Town and Country Planning (Environmental Impact Assessment) Regulations
2017 (as amended)

Scoping Opinion with regard to Solar PV array at
New House Farm Cotton Lane, Cotton, Staffordshire ST10 3DT

Fig. 1 – Caudon early tram and rail routes (bold green)

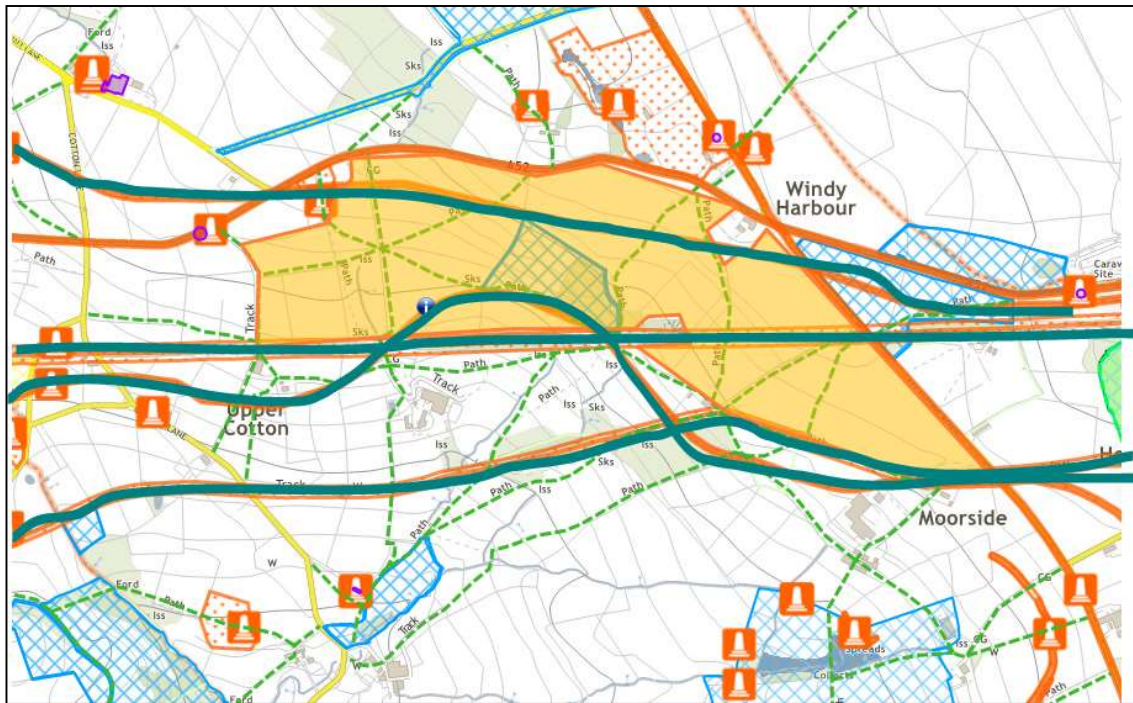
7. The Council for its part would wish to add an important archaeological factor relating to the application land. Your attention is drawn to the Staffordshire Heritage Environment Record and specifically MST4403 – earthwork dated 1777, probable first route of tramway / plateway between Caldon Canal and the Cauldon Low limestone quarries; MST4404 – earthwork 1780, probable 2nd route of tramway / plateway between Caldon Canal and Cauldon Low quarries; MST4405 earthwork 1802-04, third of four successive tramways between Caldon Canal and the Cauldon Low Quarry; MST3253 final of four successive railway lines built to connect the Cauldon Canal at Froghall to Caldon Low 1849. It is recommended that you consult directly with the Staffordshire County Council Archaeology service on these and any other non-designated heritage assets. The recorded positions of the tramway routes relative to the application site are marked approximately in dark green on fig. 1 below.

8. Notwithstanding the remarks at 4.5.1 and 4.5.2 of the RSK information report the Council is concerned that on this moderately steep and laterally undulating site the degree of land disturbance to establish the development together with all tracks and drainage management etc. may not readily be mitigated to safeguard the extant archaeology which has been identified. From the information available the Council now considers that Cultural Heritage in order to give due consideration to archaeology impacts needs to be elevated in significance and '**scoped in**' to the ES. This stance is given additional weight in the Council's view by the response from Historic England who inform us that the tramways are being considered for Scheduled Monument status and therefore:

12. CVCS refers to the historic tramways/ roads as four major linear routes with above ground features that crisscross the area and all of which would be impacted. They are the 1776-1778 plateway; the 1783 reconstruction; the 1804 Rennie tramway and the 1849 Trubshaw line, pioneering developments of their time and completely different types of historically important very early 'railways'.

- Cultural Heritage impacts – with particular regard to the 18th and early 19th century tramways / plateways and railways
- Water – with particular regard to managing run-off both in terms of volumes and in terms of any potential contaminant contents
